UNITED STATES PATENT AND TRADEMARK OFFICE

APPLICATION NO.	FILING DATE	FIRST NAMED INVENTOR	ATTORNEY DOCKET NO.	CONFIRMATION NO.
09/882,043	06/18/2001	Ho-Han Ryu	6192.0174.AA	1375
7590	05/18/2004			
McGuire Woods LLP 1750 Tysons boulevard Suite 1800 McLean, VA 22102-4215			EXAMINER	
			RAO, SHRINIVAS H	
			ART UNIT	PAPER NUMBER
			2814

Office Action Summary	Application No.	Applicant(s)
	09/882,043	RYU ET AL.
	Examiner Steven H. Rao	Art Unit 2814

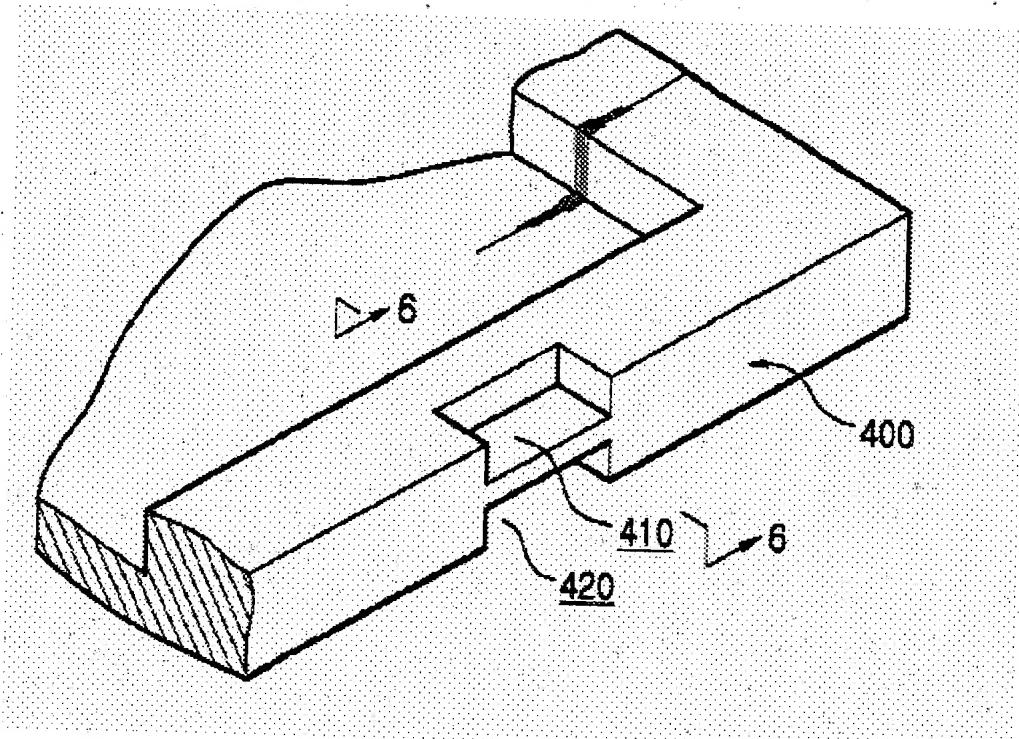
Applicants' first argument with respect to claim1 (and depend claims 2-5) that Ha fails to disclose " a mold frame comprising ..a first engaging hole formed through the main panel thereof" is not persuasive because Ha at least in figure 5 (reproduced below) shows engaging hole (410) in mold frame 400.

FIG. 2

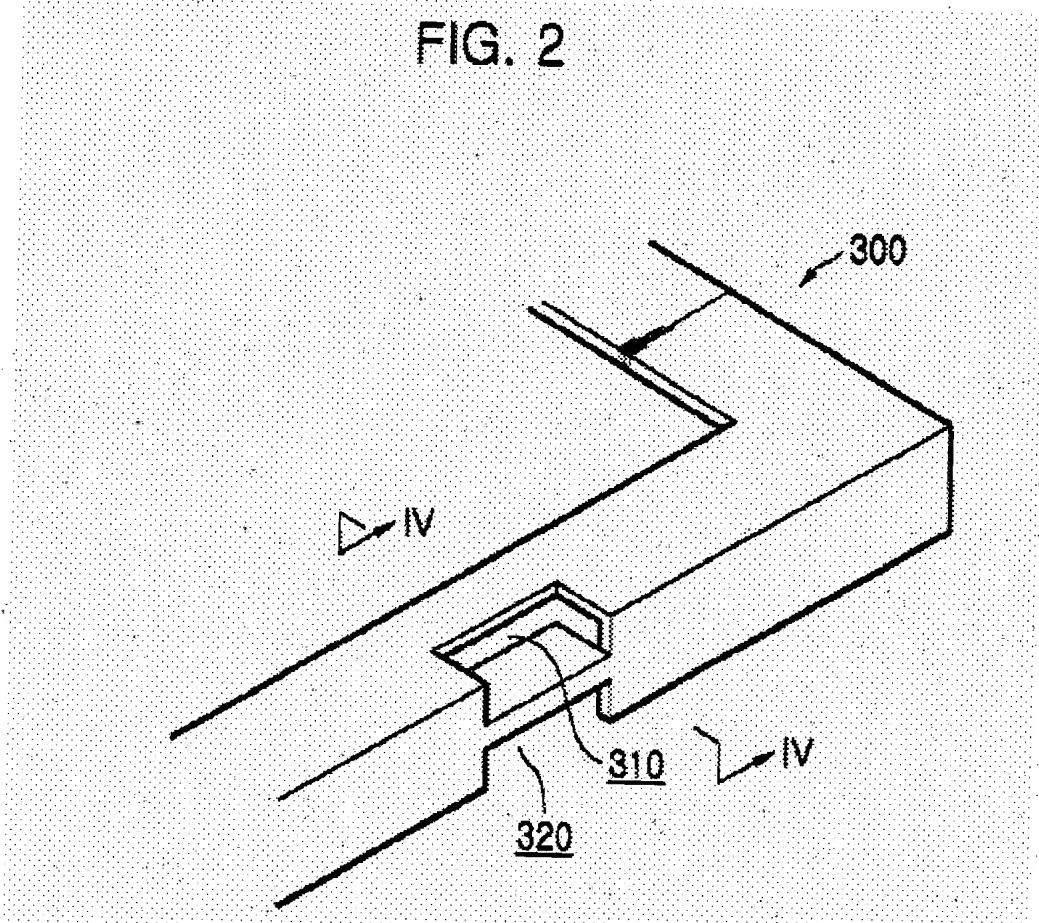
and further the top chassis (300) having a second engaging hole(310) formed corresponding to the first engaging hole (410 seen in figure 1) is shown by Ha at least in figures 2 and 1 reproduced below:

FIG. 1

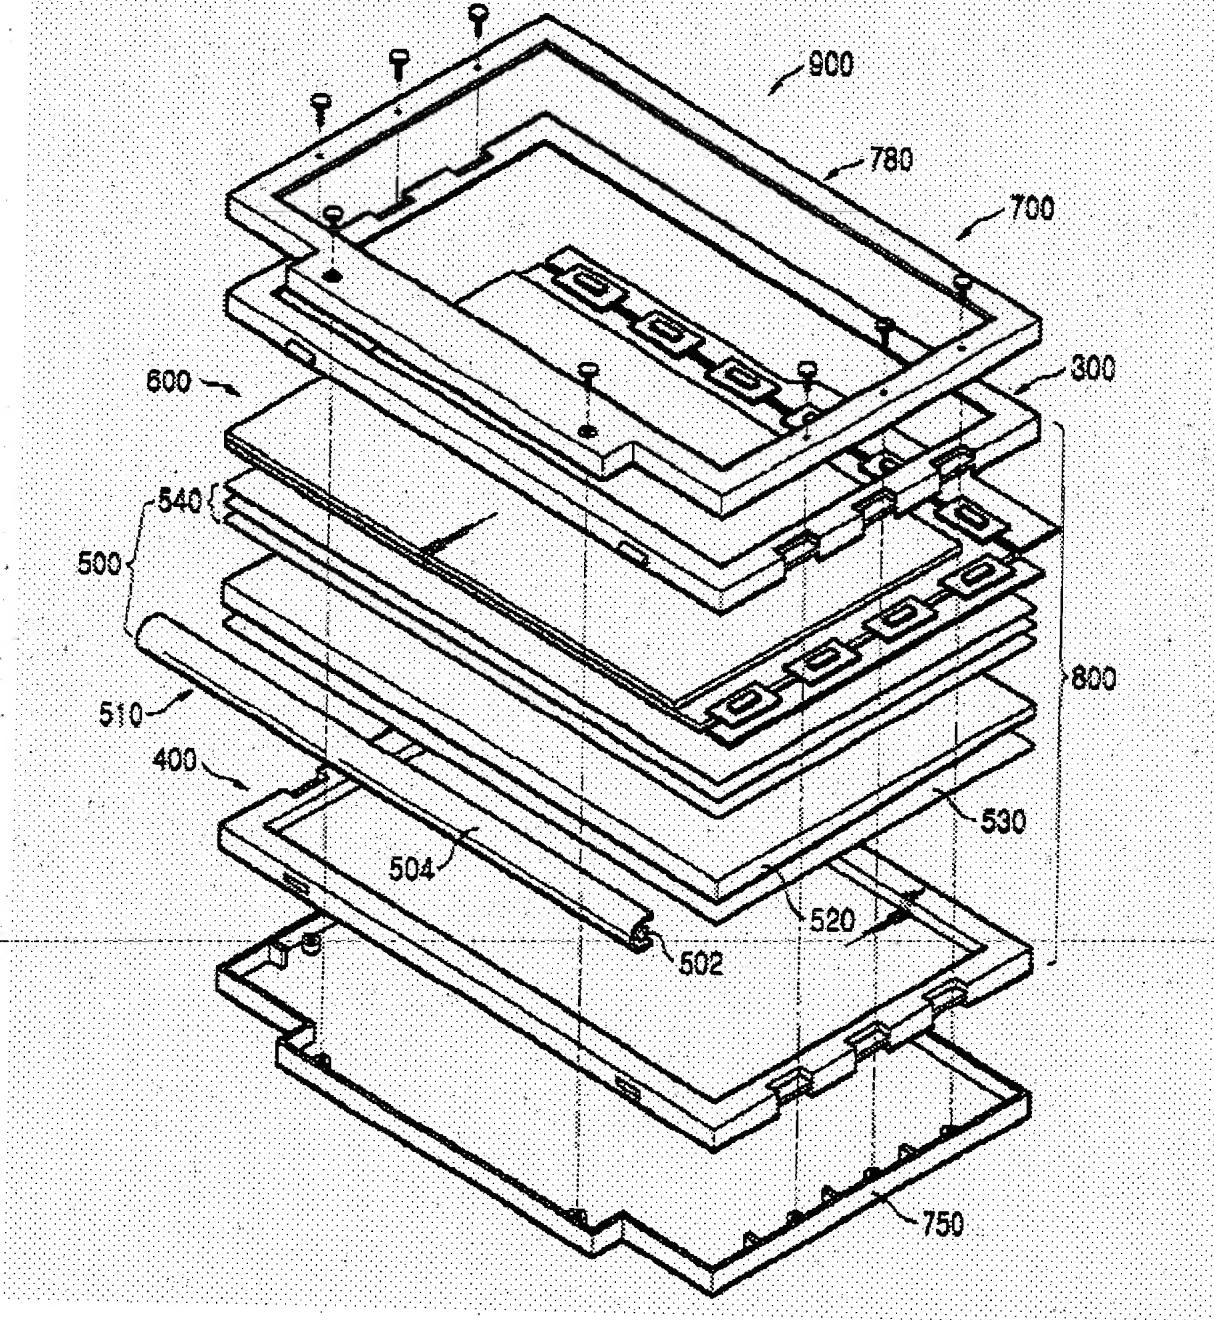
In claim 6 the recitation ; " an engaging... penetrating through the first and second engaging holes to assemble the mold frame and top chassis" is also described/ taught by Ha in figure 1 above , wherein screws (not numbered) penetrate through holes-310-and-410.

Applicants' may amend their claims 1 and 6 to recite : e.g. wherein the screw (instead of the engaging device) passes through the first and second engaging holes entirely within the first and second holes" or similar language which will exclude screws (engaging devices) penetrating the outside of the first and second engaging holes.
